## Lahontan Regional Water Quality Control Board

### **2016 Basewide Annual Monitoring and Operations Report for CERCLA and Non-CERCLA Sites, Former George Air Force Base, Victorville, San Bernardino County**

Figure 8. Upper MLU during GETS spreading.

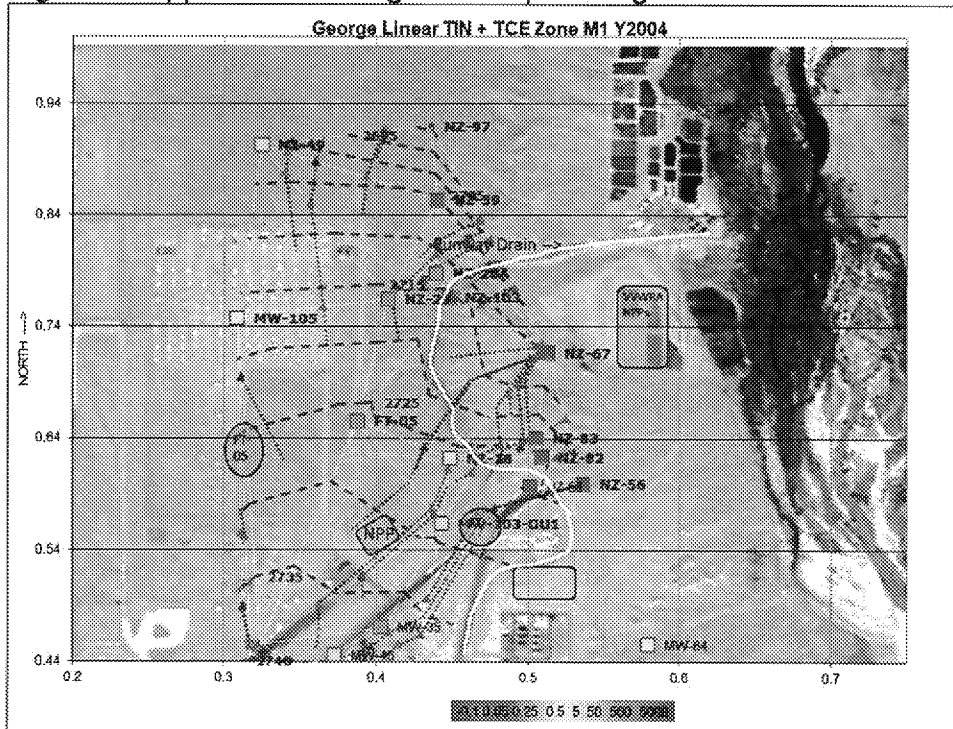
fresh water. A contour map of the upper MLU (M1) for 2004 is attached as Figure 8, and can be compared with the 2016 M1 contours (Figure 9), 2016 middle MLU (M2) contours, and 2016 Upper Lower Aquifer (L1) contours. The first point to observe is that for both years, the three wells were in an area of east-northeast flow, but at the very edge of the M1 part of the MLU. Figure 9 shows flow in the M2 zone, and wells NZ-53 and NZ-54 have high concentrations of TCE, which evidently has drained to them from the M1 zone. Finally, Figure 10 shows the upper part of the Lower Aquifer, and shows high TCE concentrations downgradient of the three wells in the M1 unit. The groundwater contour evidence shows that the 'attenuation' consists of contaminants flowing off the MLU edge and landing on the upper part of the Lower Aquifer. NZ-52 has high nitrate, and the water there likely originated near the STP ponds. The distribution of PCE also matches this flow pattern. The section should be revised or removed.

Figure 11. Particle tracks near NZ-72 in upper Lower Aquifer, 2007.

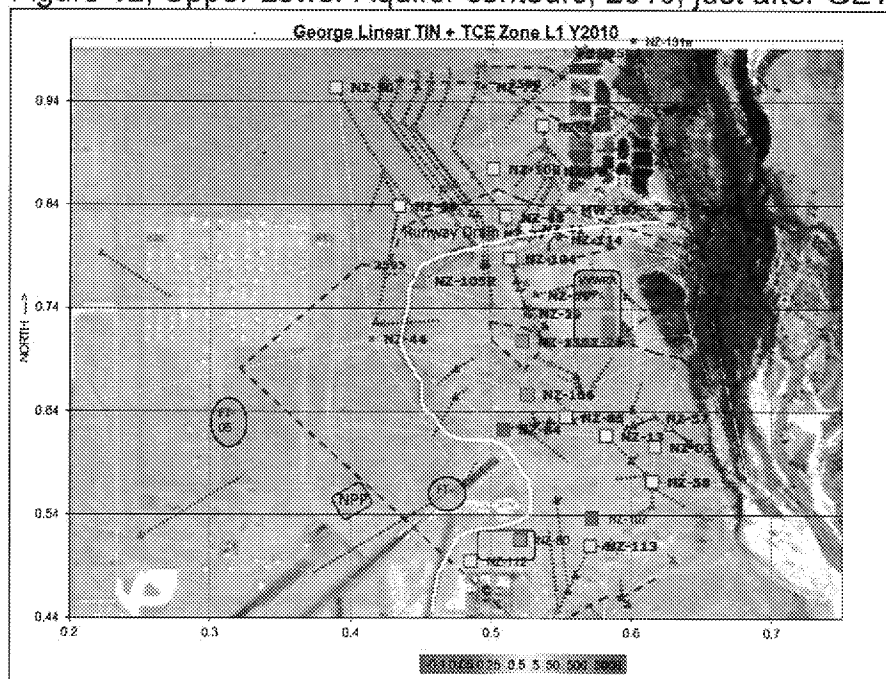
9. Section 4.4.2.2, first bullet. Well NZ-72 is at the northeast leading edge of the plume. The 2010 particle tracks (Figure 11) show that NZ-48 was generally upgradient of NZ-72. Flow in the Lower Aquifer is locally dominated by mounds beneath the VVWRA ponds and the runway drain, and the contaminated water now at NZ-72 appears to have originated near the runway drain, but was pushed North and will eventually be replaced by mounded recharged water. Water draining the Upper Aquifer has TCE, and is therefore not now reaching NZ-48, which is now upgradient of NZ-72. Groundwater in the lower zone upgradient of NZ-72 swings clockwise around the pond complex to reach the river east and north of the VVWRA treatment plant. The mounding from the ponds appears to be the main driver of both horizontal and vertical gradients, as well as the mechanism for reduced concentrations of TCE in wells near the mound, and this should be mentioned in the section.

Figure 1, illustrating section from RZ-02 to OW-06

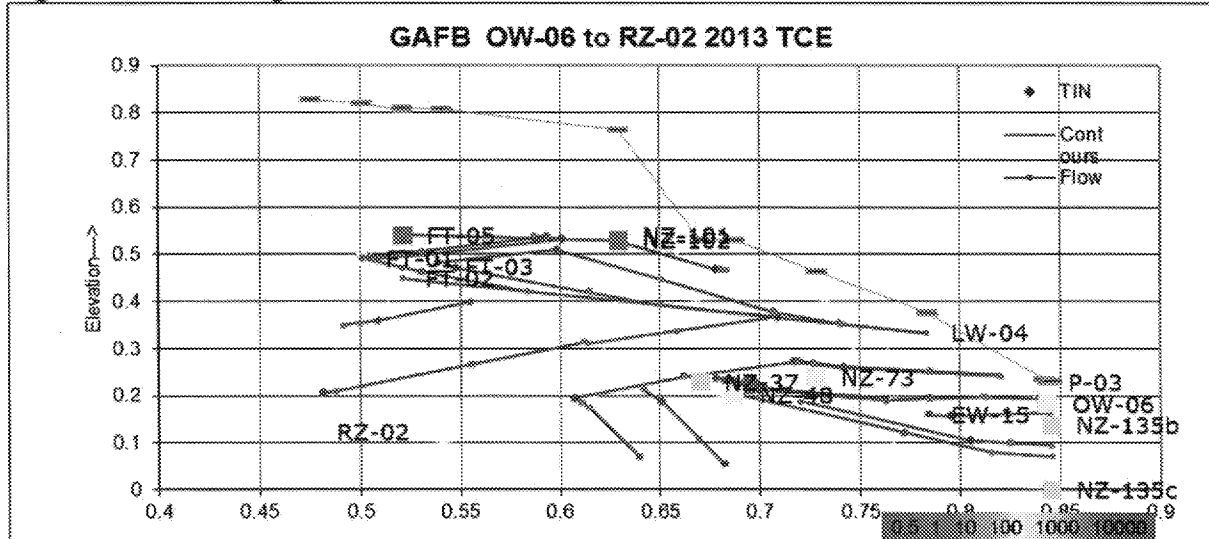
3. Figure 3.1 The cartoon of the CSM leaves out many relevant details found in the earlier 2011 Focused Feasibility Study. In particular, the Lower Lacustrine unit is not flat, but it dips downward to the south. The shape of this zone is important in downward migration of contaminants. Attached is a cross section (Figure 1) showing groundwater streamlines and TCE concentrations along a line between the Fire Training area and the Victor Valley water treatment plant. Streamlines show an initial northward trend, but also a southward trend in the Lower Lacustrine unit. Where the perched zone ends, contamination is seen in the Lower Aquifer. Attenuation across the vadose zone is not great, because concentrations at Lower Aquifer well NZ-37 are only an order of magnitude

Figure 3. Figure illustrating effect of both water levels and high rainfall on TCE concentration.

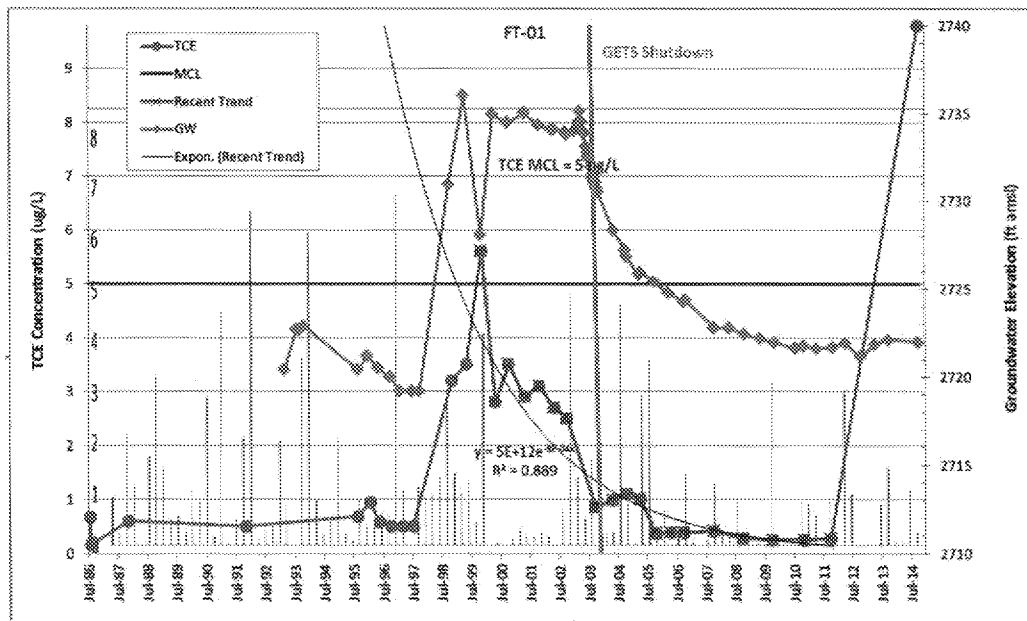
6. Section 3.3, TCE Concentrations vs Conceptual site model. The CSM has many unstated assumptions and is not entirely consistent with observed trends in the time series charts. The time series charts show pulses of contamination, not steady-state sources, indicating that the initiating events are short-term. In some cases this can be tied to infiltration ponds located near source areas, but not in all cases. While downward percolation of water is one mechanism for moving contamination into groundwater, there is another mechanism that has not been identified. Attached is a figure (Figure 2) showing Well FT-05 in the FT019 area. Superimposed are water levels and the well log for the well. It shows that the groundwater surface rose into a source zone, and the TCE release occurred immediately, and declined with the water levels until recently, when a small pulse occurred. The following figure (Figure 3) shows rainfall superimposed, and it suggests that infiltration of rainfall through source zones also moves pulses of contaminants independent of water levels. The recent increase in TCE concentration was not a result of rising water levels. These mechanisms need to be described in this section.

Figure 4, Pulse fit model showing concentration versus time for a pulse fit to data from FT-05. Error is less than 1%. Compare with exponential fit below:

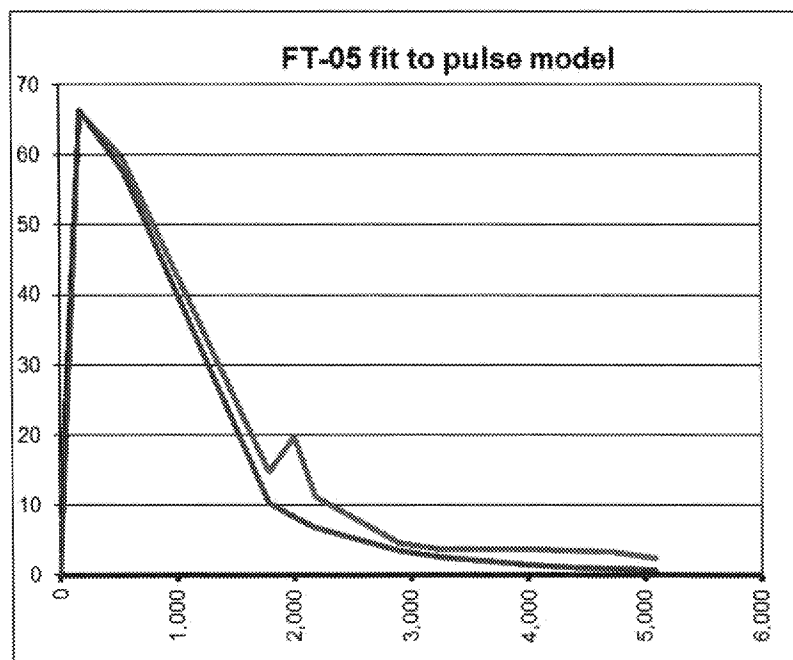
8. Section 3.4. The discussion of the attenuation mechanism would benefit by preparing a pulse model similar to GSUs (see Figure 4). The fit required attenuation by retardation, and would not fit without it. The pulse fit required a velocity of 0.08 ft/day, retardation, no decay, and minimal dispersion. The section should be revised based on a better mechanism and model fitting. Note that the hydraulics of the plume involve moving water across the Lacustrine Unit to the Lower Aquifer. From the point of view of the lower aquifer, this would behave like a leaky aquifer, where the flow from leakance would add to the flow in the Lower Aquifer. Using a conductivity different of 10%, the Lower Aquifer concentrations would look like a 10% attenuation, which is consistent with observed concentrations and with Figure 3-1. The EPA model is for a homogenous, isotropic aquifer. The system at George is considerably more complex, but is still tractable. The attenuation model should be revised. Note that Figure 3-1 implies a steady-state, attenuating plume, but in reality the upper aquifer generated a saturation pulse that is now in a slow drip phase.

Figure 6, showing locally derived pulses passing by NZ-129b.

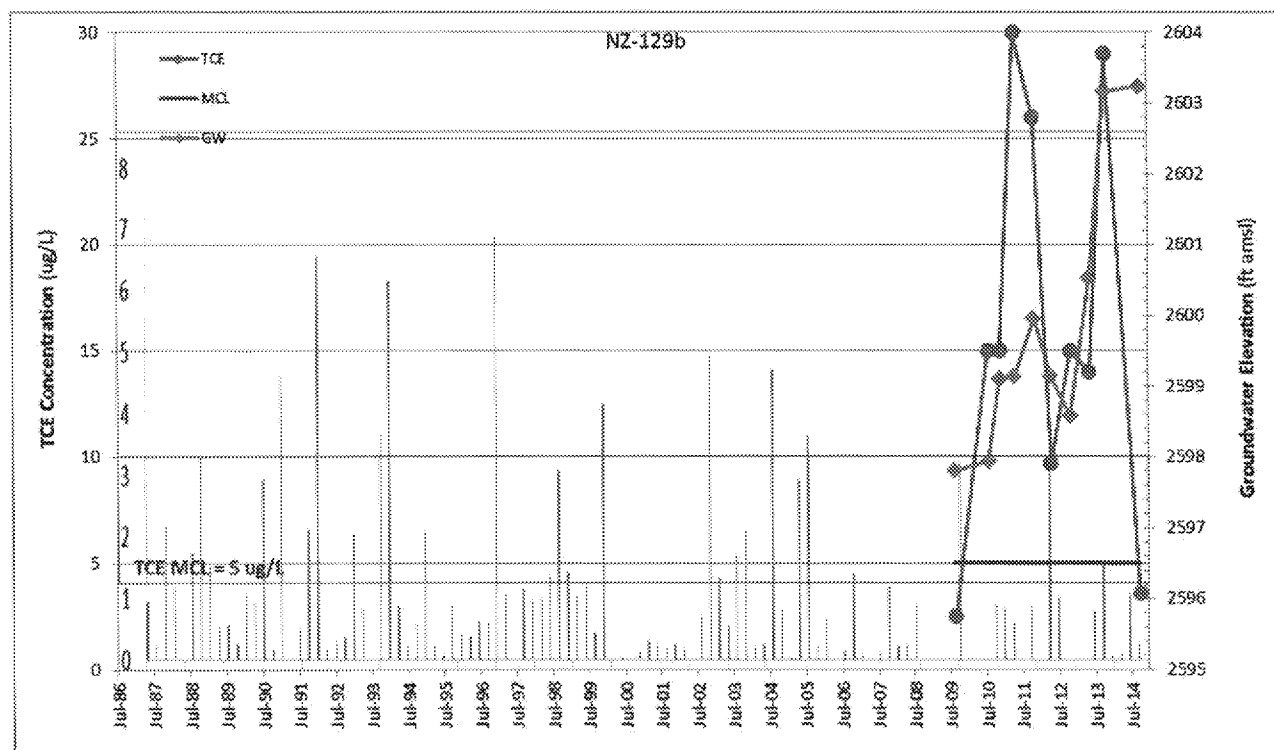
14. Section 2.2.4 Well NZ-129b shows two distinct pulses, echoed by NZ-129c at about 10% of the concentration of the shallower well (see Figure 6). This demonstrates downward migration, not horizontal flow towards the river. Wells 130a and 130b show the same pulse at the same time. The narrow pulses are not the remains of a decaying pulse that has moved a long distance, because it happens too fast. This pulse originated somewhere very close to the wells. Both TCE pulses happened just after water level peaked, fell, and peaked again, suggesting a link between the water levels and TCE concentrations. The pulses are similar to what happened at the fire training area, which seemed linked to saturation of contamination near the water table by a rise in the water table. This in turn suggests that source removal would prevent future contaminant releases to groundwater.
